RE: Site Plan Review-Peer Review
#1355 Main Street Energy Storage System (ESS)
ZP Battery Devco, LLC
Map 26/Parcel A1

SITE DEVELOPMENT PLAN SOLAR ENERGY STORAGE SYSTEM (ESS)

1355 MAIN STREET

SITE DEVELOPMENT PLAN IN LEICESTER, MASSACHUSETTS

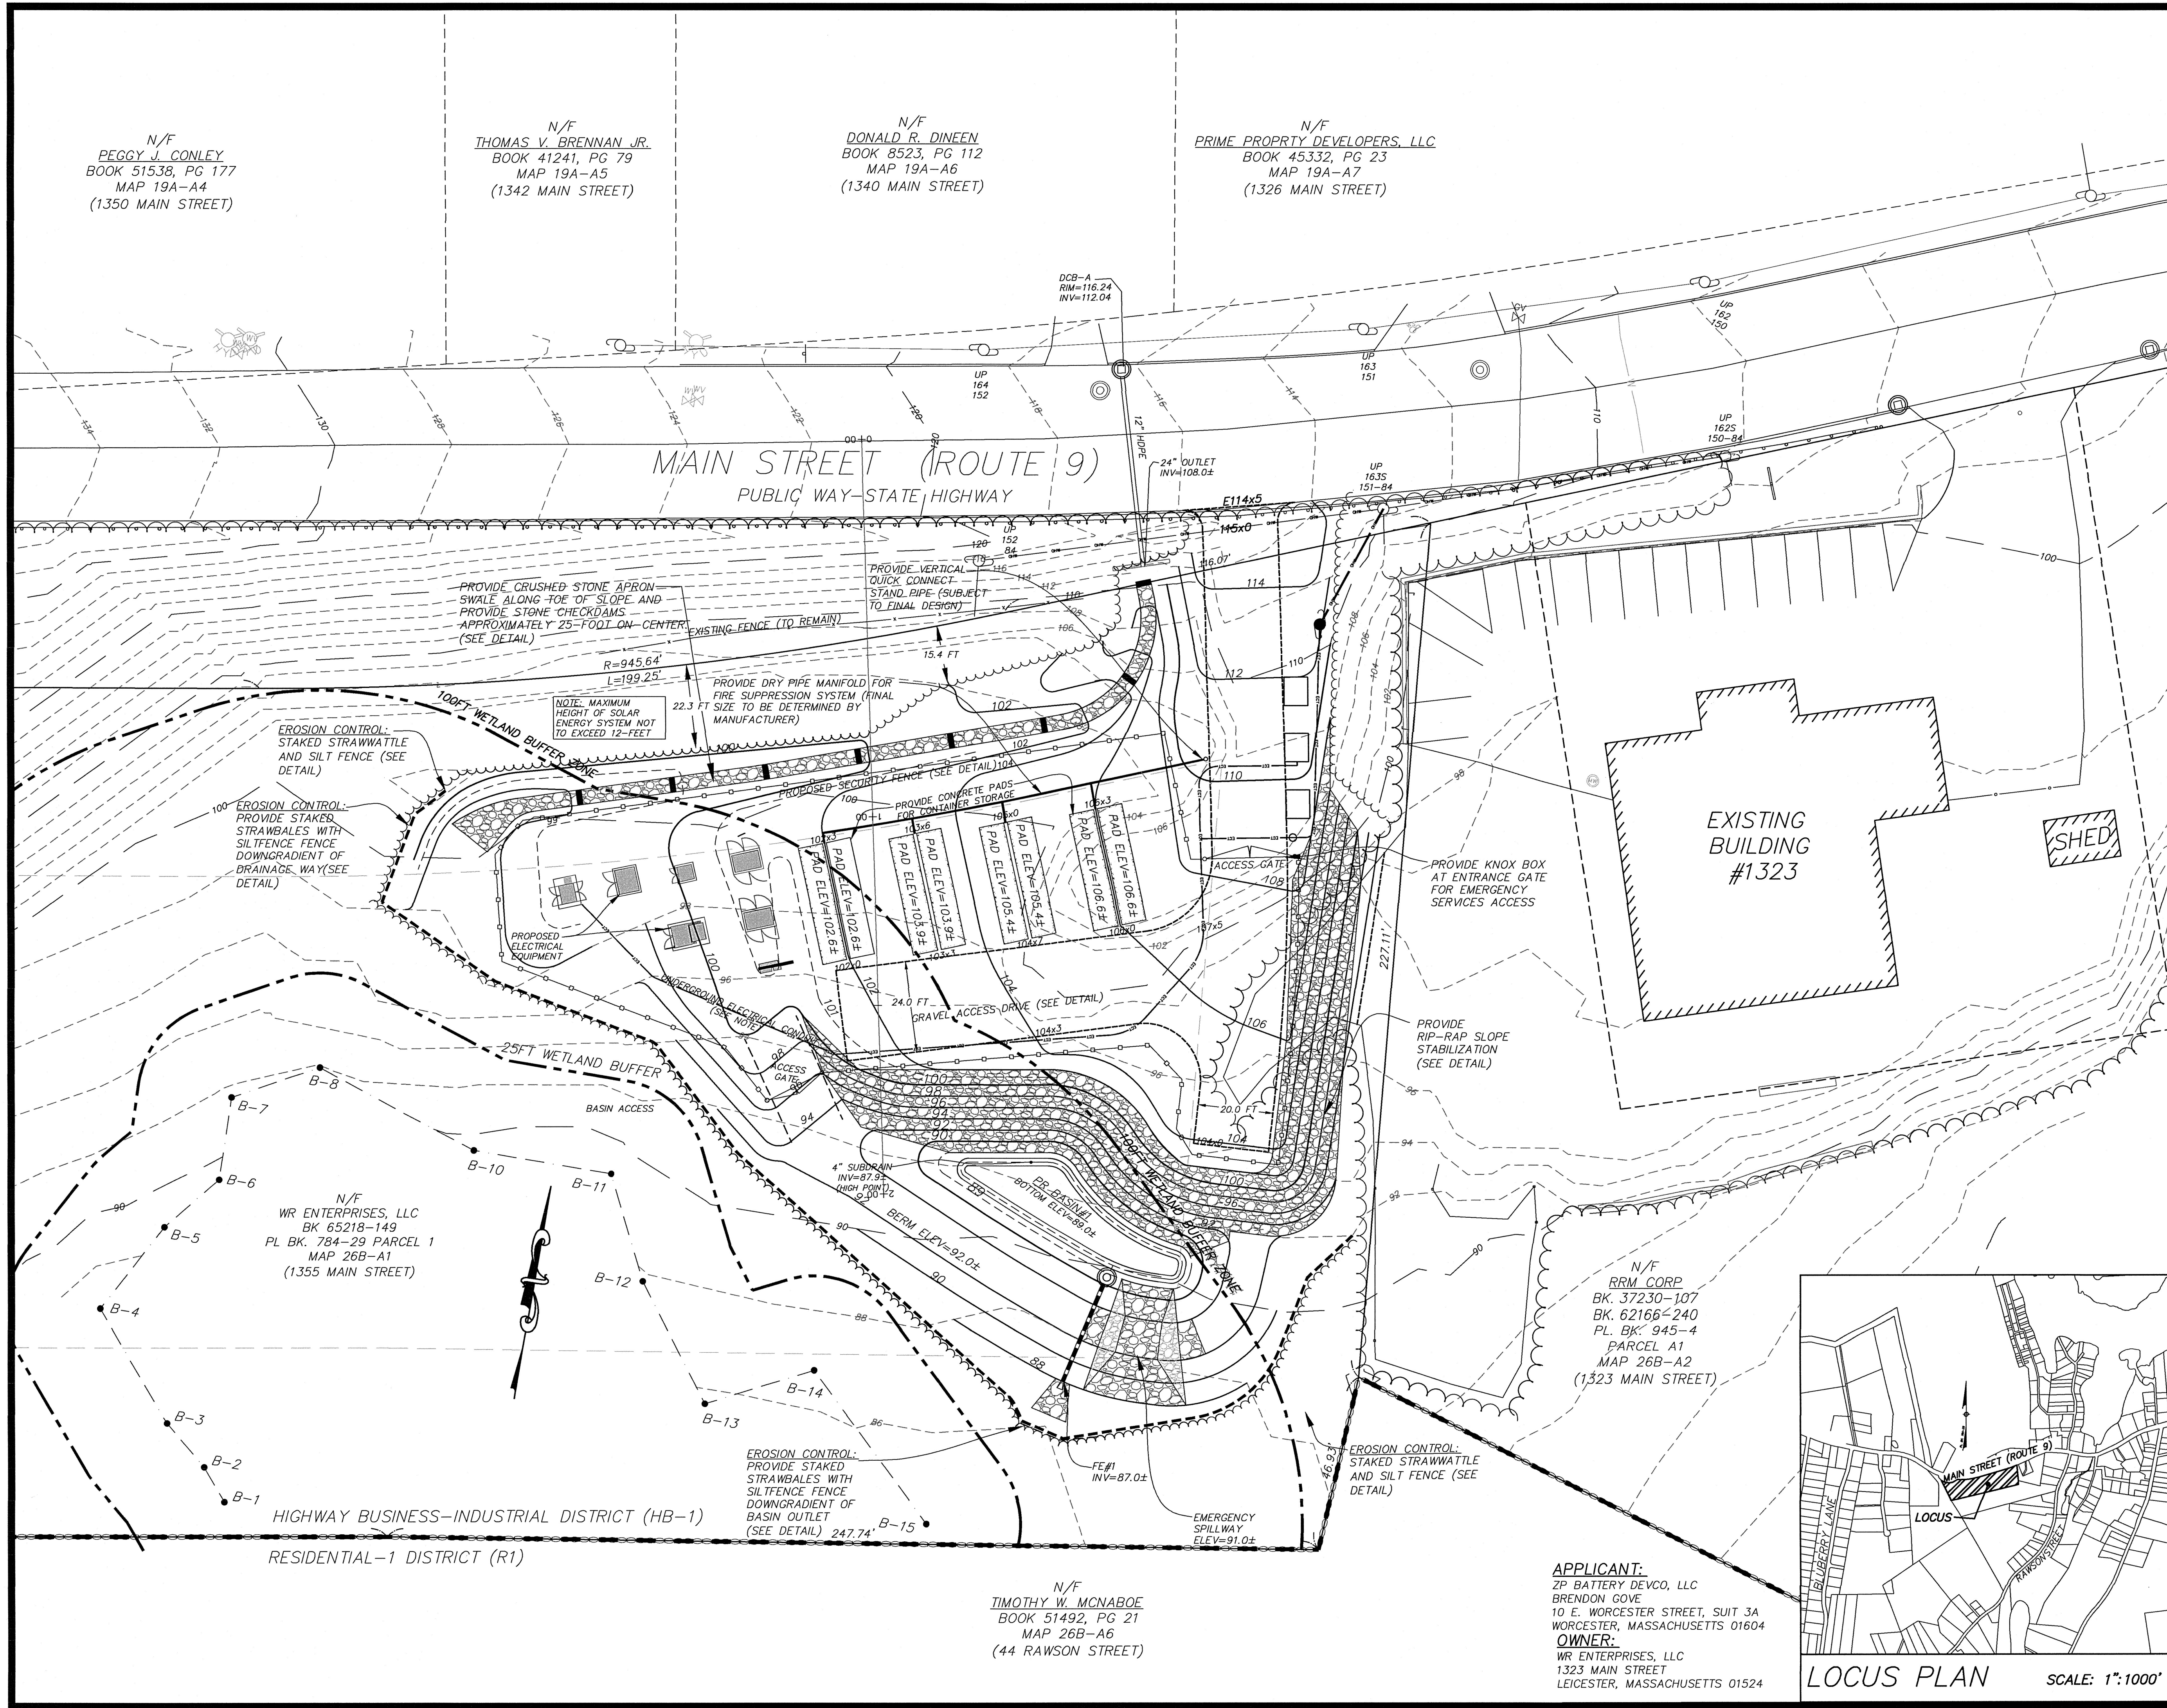
Comment #11: Based on the proposed grading, it appears that runoff from the easterly equipment pads may not flow to the basin as intended. The grading should be revised to ensure that the intended runoff reaches the basin.

Comment #8 10/28/21: The grading has been revised to depict a shallow swale at the end west end of the equipment pads, however based on the revised grading, the runoff in the swale will flow towards the proposed access gate and does not appear to flow into the basin. The plan should be revised to depict a more defined channel directing runoff into the basin in order to ensure that the intended runoff reaches the basin

Comment #15: Check dams are recommended along the flow path of the existing discharge from the catch basin in Main Street to minimize erosion potential along the toe of the proposed slopes.

Comment #8 10/28/21: Check dams and a defined rip rap channel have been proposed along the flow path from the existing culvert. The Applicant should confirm that channelizing the flow does not increase flows to the downstream property.

Response: The driveway has been pitched as to create a channelized flow from the pad area to the detention basin.

Response: The HydroCAD model has been updated to depict the channelized nature of the flow relative to the peak rate impacts to the design point.
